Matthew Rosel - Shepherds Bay - Council Report 25 February 2014 and Proponent's Response to Council's Issues

PROPONENT'S RESPONSE TO COUNCIL'S ISSUES - CONCEPT PLAN S75W (Shepherds Bay)

PROPONENT'S RESPONSE TO COUNCIL'S ISSUES – STAGE 1 PROJECT APPLICATION S75W (SHEPHERD'S BAY)

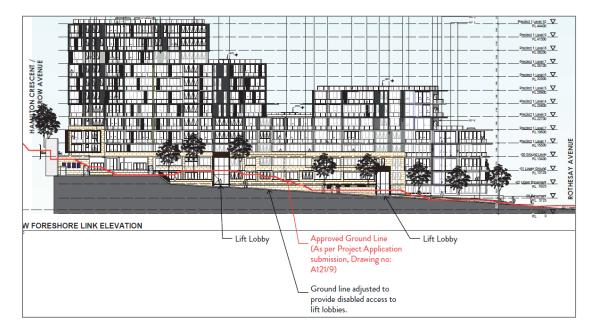
As demonstrated in the section below (taken along the Foreshore Link and showing the western elevation of the Stage 1 building) the red line demonstrates the Ground Line as per the approved Project Application. The proposal seeks to adjust the ground line to provide disabled access to lift lobbies and throughout the Foreshore Link. Thereby improving the public domain treatment and accessibility whilst maintaining the overall RL height.
